Addendum #1

Date: November 19, 2021
Project: **Offsite Waterline Supply**
Lukachukai Community School Replacement
Location: Indian Route 12
Lukachukai, AZ 86507

RE: LCS & NHA Offsite Waterline, Lukachukai AZ – NTUA-HQ Review @ 'Pre-Final' Submittal

3. INSTALL 6" DR18 C900 PVC WATERLINE.
4. INSTALL 6" GATE VALVE (MJ X MJ) AND VALVE CAN PER NTUA STD DWG WS-14. SEE SHEET D-02.
6. SPELL OUT COMBINATION AIR VALVE (CAV).
9. INSTALL 1" CAV PER NTUA STD DWG WS-10. SEE SHEET D-02.
10. INSTALL 45° BEND (MJ X MJ) WITH THRUST BLOCK PER NTUA WS-19.

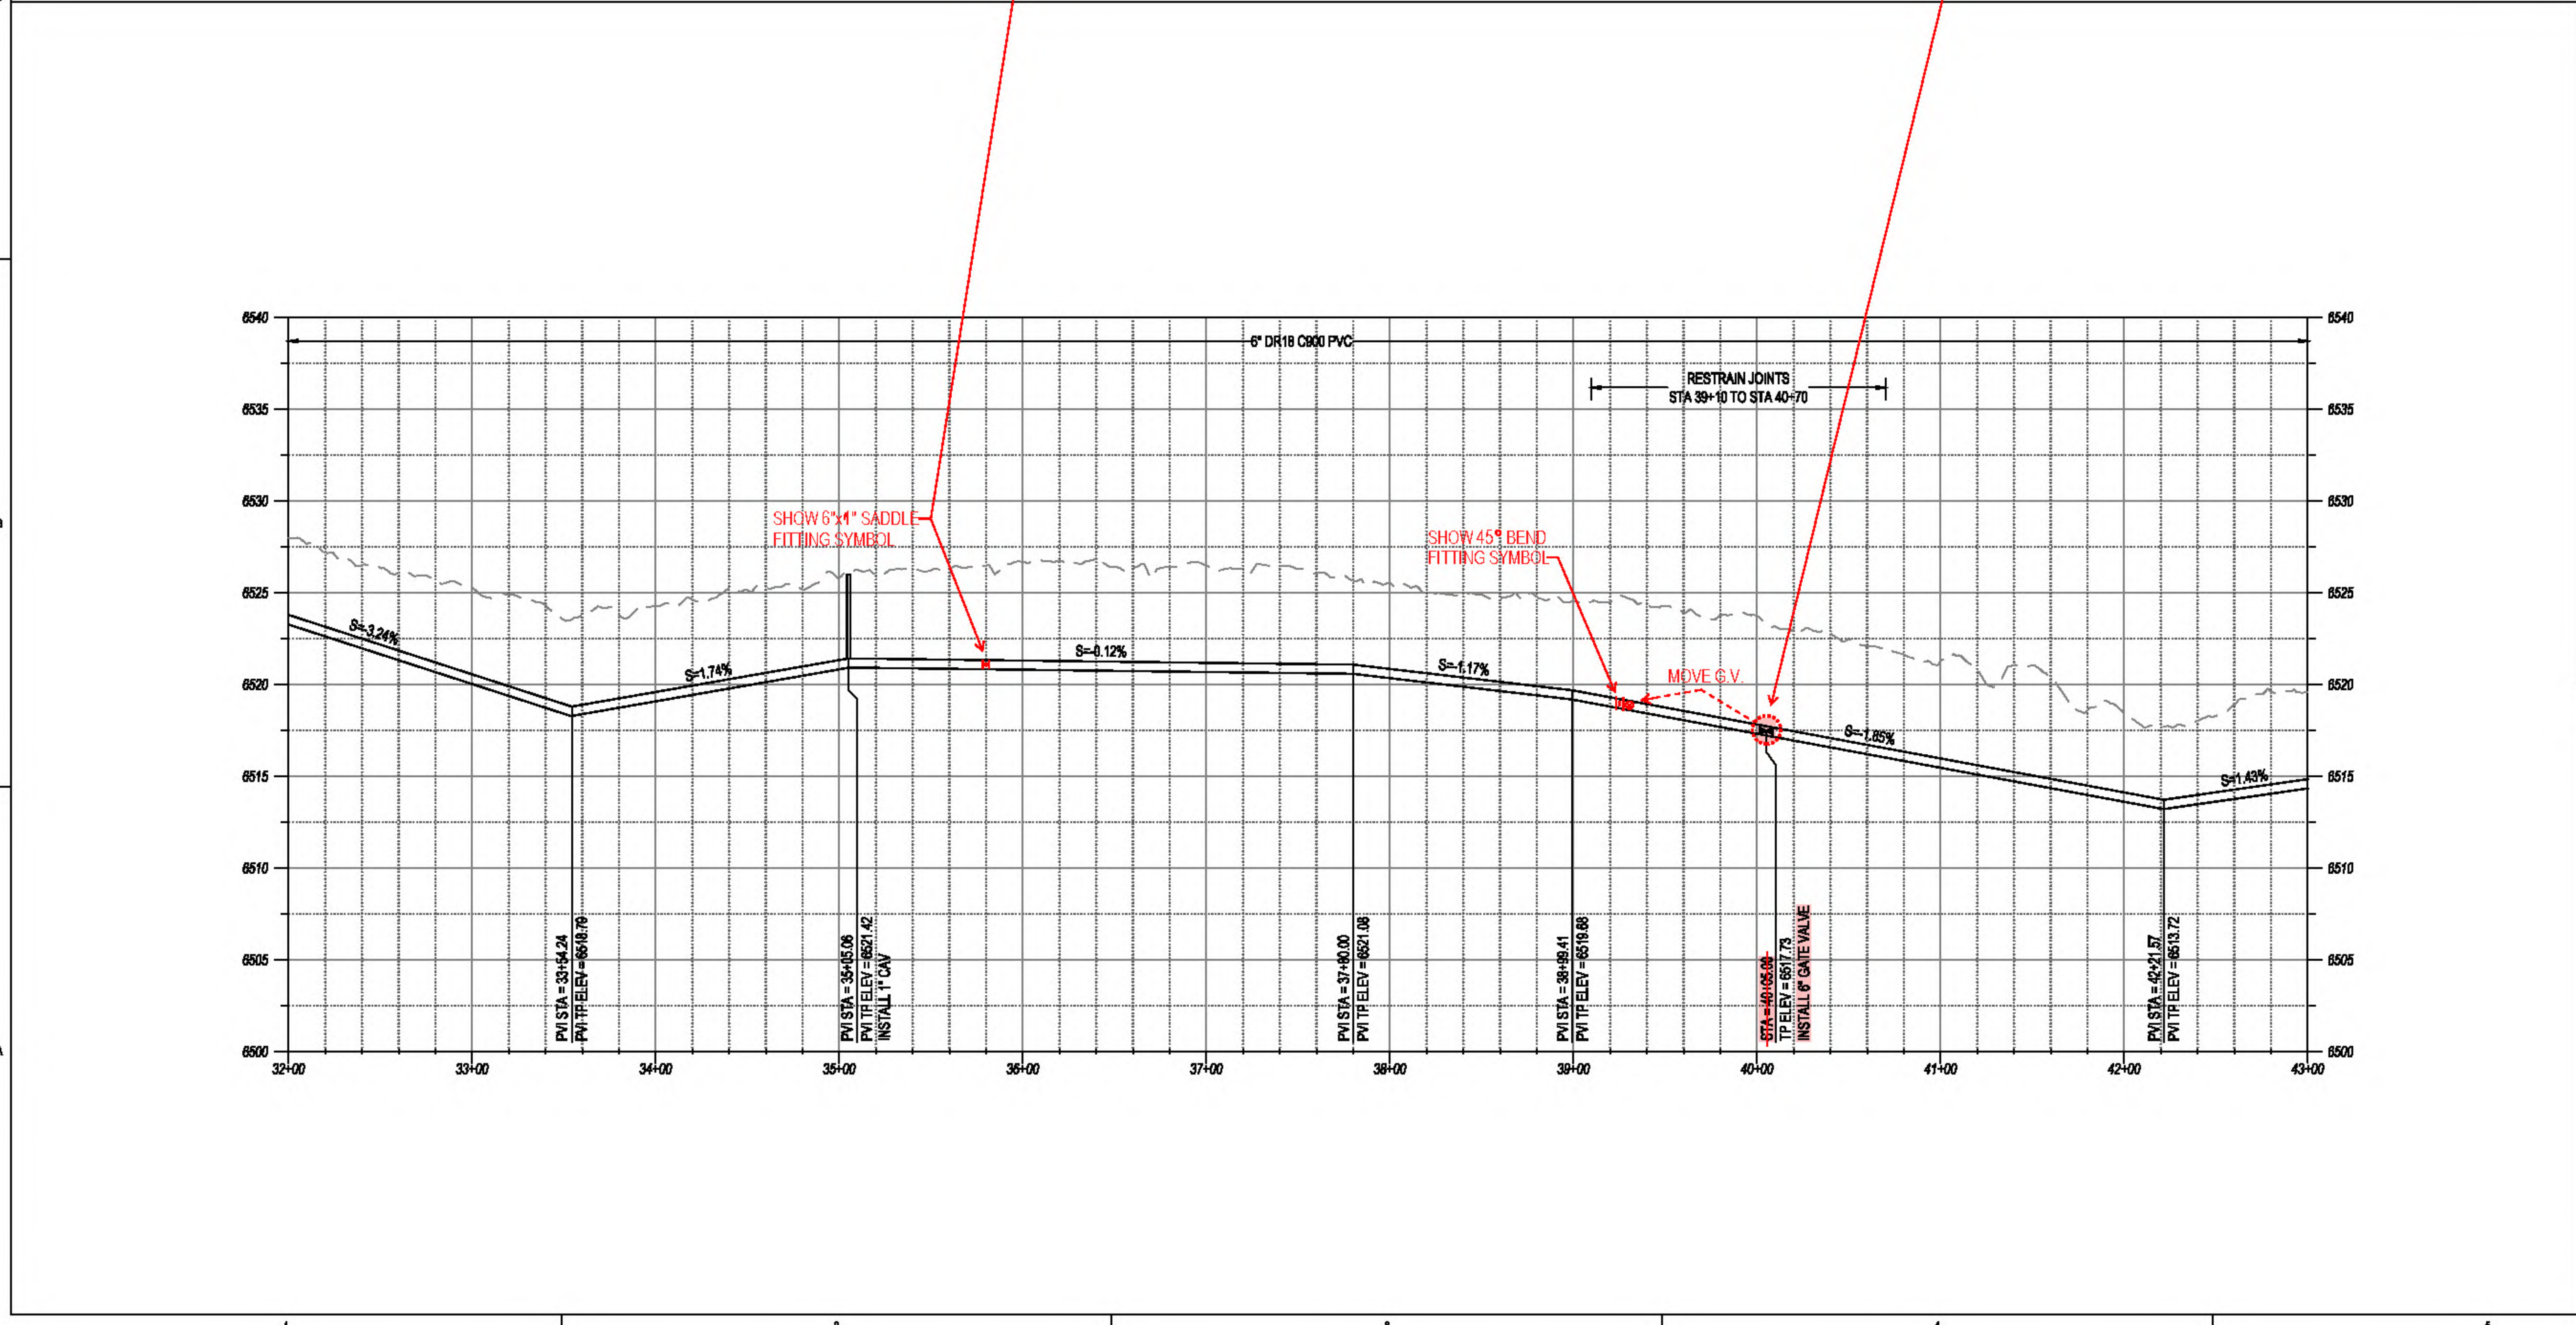
1. Ex. 2" PVC W/L: Callout the ex. 2" waterline **only** from Sta. 21+00 to Sta. 26+30(+/-). This approximate Sta. area is where the ex. 2" waterline ends. Adjust/fix the ex. 2" waterline alignment to end here, as shown on the plan sheet. Also callout to be 'abandoned in-place' as shown. Delete/erase the shown ex. 2" waterline alignment that is shown from Sta. 26+30(+/-) to Sta. 32+00, which is the matchline for this sheet. This does not exist in the field.

2. EOL for ex. 2" W/L: Blow up the EOL area with a detail bubble as shown on the plan sheet. Show/add the detail bubble review comments as shown per the ex. water facilities near the EOL.

3. Ex. Curb Stop at ex. Homesite: The ex. curb stop to remain, protect in-place. The new 6"x1" saddle tap on the new 6" water main will align directly in-line w/ the ex. curb stop location. Future water service re-connection will utilize the ex. curb stop. Also, label the House No. # and/or Homeowner name (typ).

4. New 6" PVC C900 W/L alignment: At or near Sta. 26+40(+/-), align the new 6" water main into the centerline of the new 30-ft water easement/ROW here. See plan sheet/detail bubble for reference.

5. Planned/future bends on the new 6" water main: The Sta. locations of the bends will change per the shift of the 6" water main into the center of the 30-ft water easement. Adjust the Sta. locations.

6. Sta. 26+38.08 (6"x2" service saddle): Where/who will this 2" water service alignment be routing to?
7. Sta. 30+05.00 (Proposed 6" in-line Gate Valve): Move/revise this gate valve to 3-ft downstream of the revised bend area once the 6" water main alignment shifts to the centerline of the 30-ft water easement, as shown in the requested future detail bubble of the EOL area of the ex. 2" waterline.

8. Ex. Frontier telecommunications/fiber line: Upon visual field verification, there looks to be an underground (UG) telecommunications line field marked w/ orange marking paint and ex. pedestals. Show this ex. Frontier line in relation to the planned 6" water main on the plan. May require coordination with the local Frontier utility office. The line looks to be following the NHA survey stakes going northbound to the next homesite residence. Possible conflict and/or Frontier relocation.

9. Keyed Notes: Make corrections to the keynote descriptions as shown on the plan sheet.

1. Planned fitting symbols: Show/label the saddle and bend symbols in the profile, as shown.
